**CITY OF AUSTIN
Board of Adjustment
Decision Sheet**

CASE NUMBER: C15-2017-0047

ADDRESS: 3602 & 3604 RIVERCREST DR

Re: Engineering Summary Letter for 3602 Rivercrest Drive SP-2016-0261D
Application for a variance to LDC 25-2-1176(A)(1) to allow construction of a boat dock
further than 30ft. from the shoreline on Lake Austin

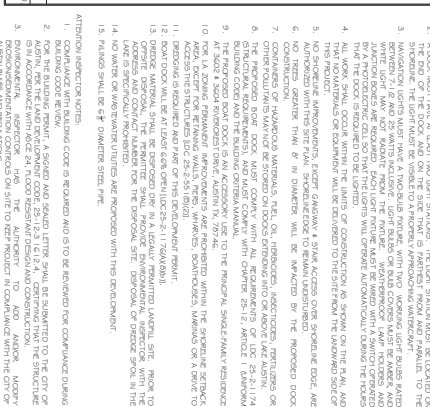
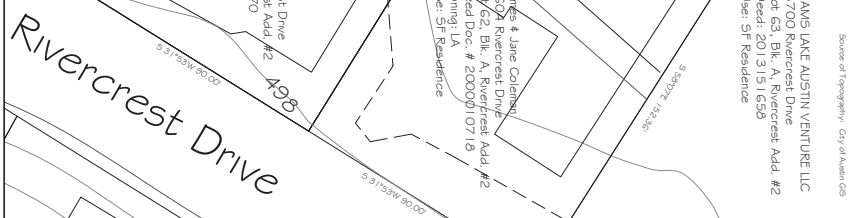
WB 2 Update 0 Site plan does not show where the dredged material will be located. Show destination of dredged material in a compliant location/method, and/or specify an enforceable method of removal.

Update 1: The note provided is insufficient. If the dredged material will be stored on site, show this location on the plan set with appropriate construction access and erosion/sedimentation controls. **YOU OK'D THESE IN OUR MEETING**

WB 3 Update 0 Provide accurate bathymetric profile information demonstrating how the 20 cubic yard dredging estimate was calculated.

Update 1: Show the dredging profile on the architectural elevation. **SEE SHEET 2**
